SUBJECT: SAFETY RECALL OF 2009 - 2012 MCI J MODEL COACHES

Ref.: **NHTSA # 12V-135**
Transport Canada # 2012-111
MCI Service Bulletin 369

Service Bulletin No. 369

MODEL J4500 Series Coaches	TYPE Field Change Program	SECTION/GROUP 3-Body	DATE June 1, 2012
SUBJECT REAR TRANSOM WINDOW			
CONDITIONS

Figure 1. Mounting hardware for transom window retention brackets.

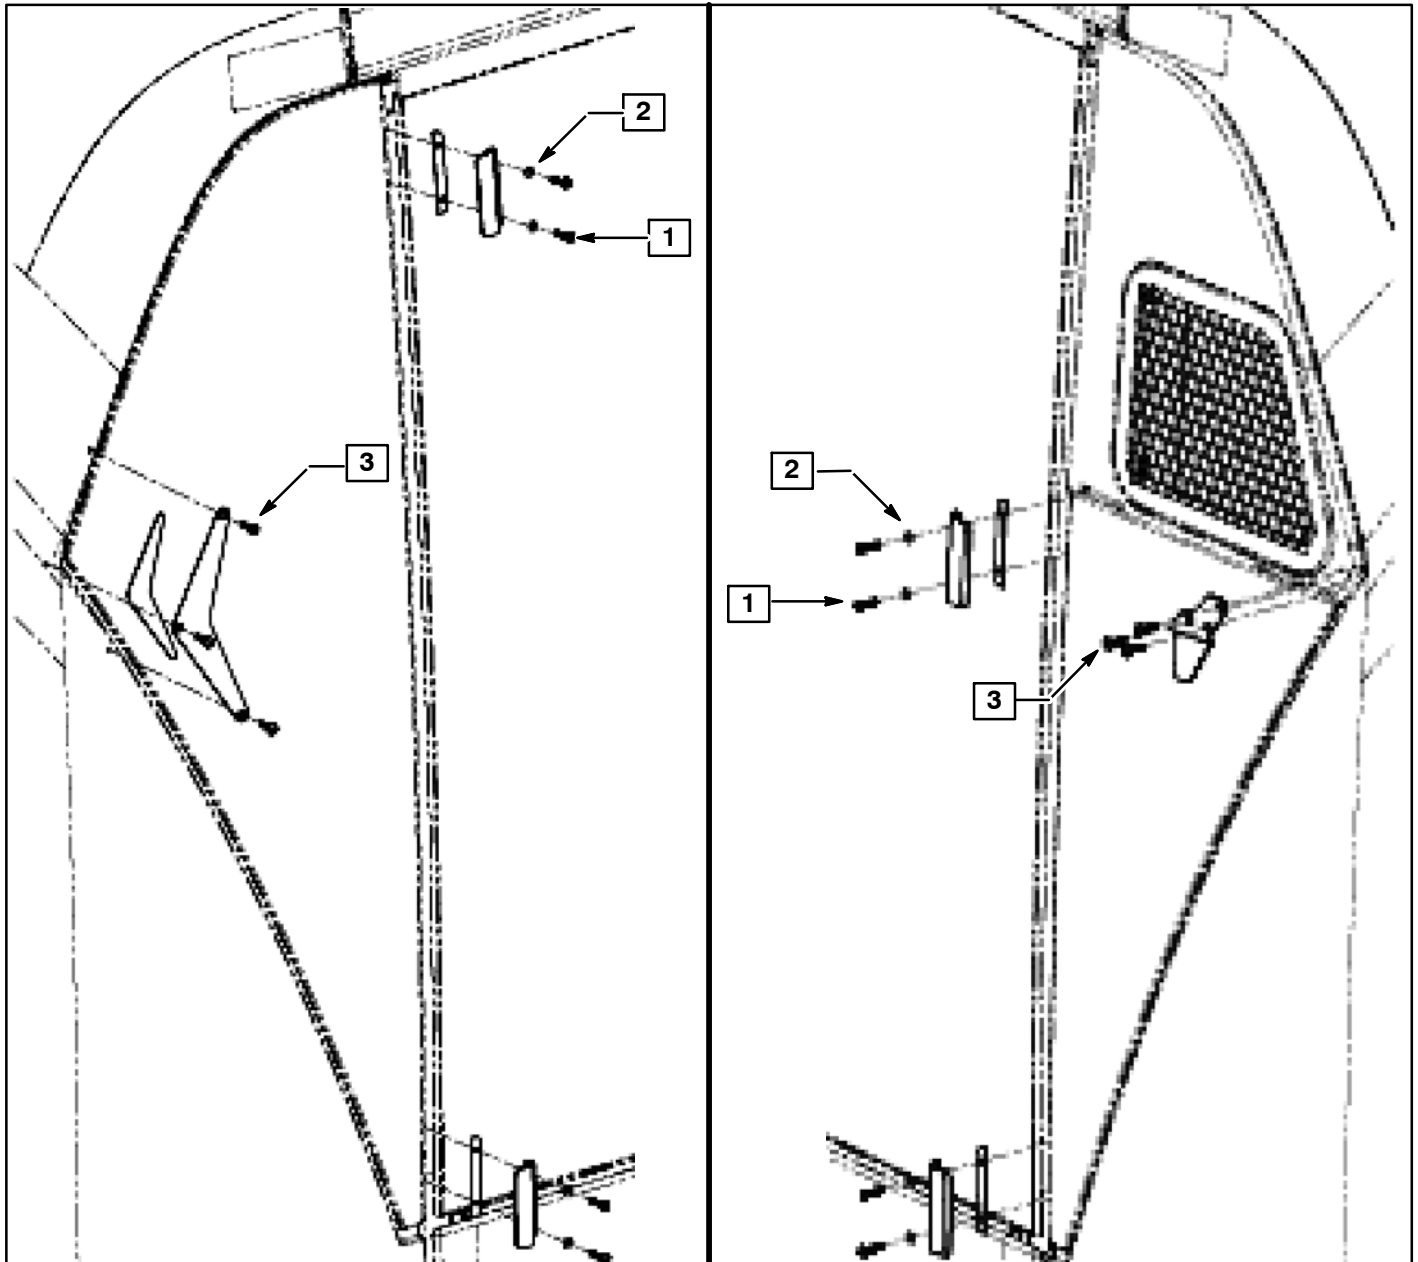
3. Using a clean rag and isopropyl alcohol, clean the installation areas per Figure 1.

Figure 2.

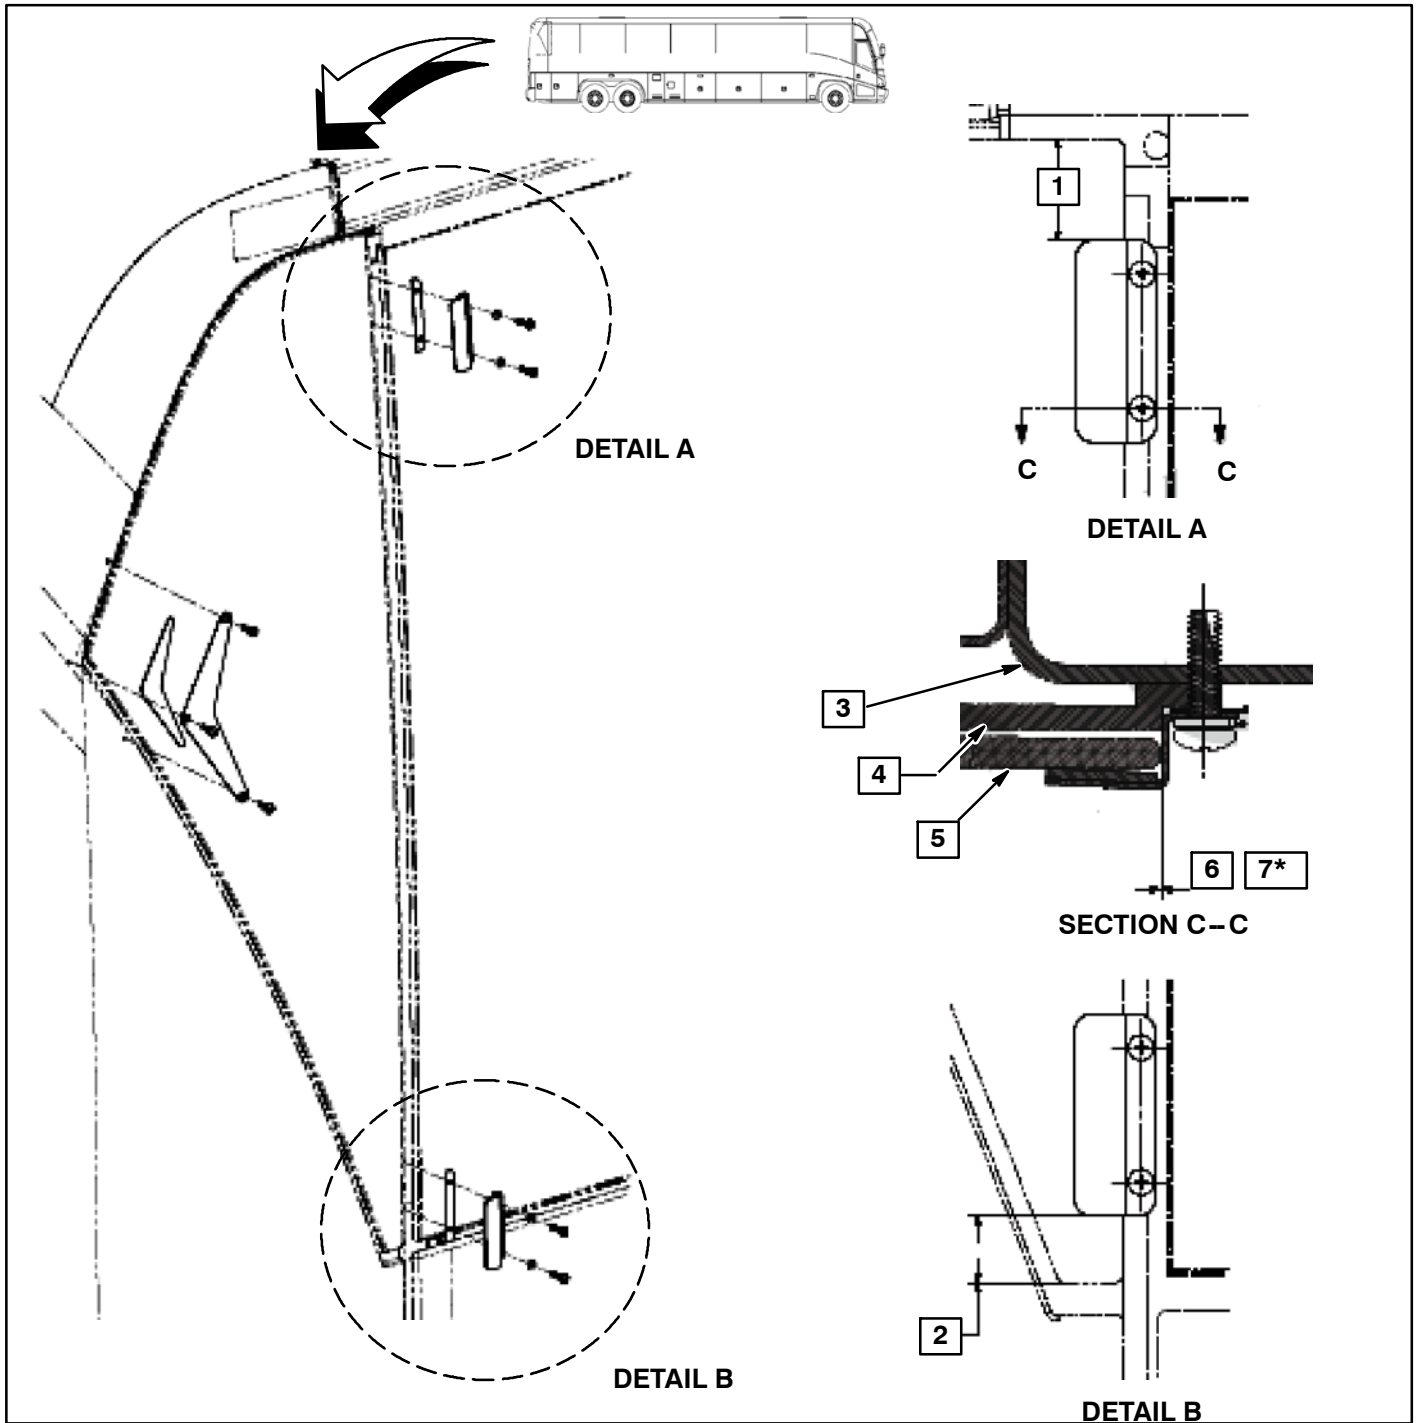
4. Orient the mounting components on the installation area per the dimensions shown in Figures 2 and 4.
5. Using a 0.161 inch drill bit and a drill bit stop set to 0.750 inch, utilize the bracket as a template to drill the holes to a depth of 0.750 inch
6. Using the applicable mounting hardware, secure the bracket to the coach frame.
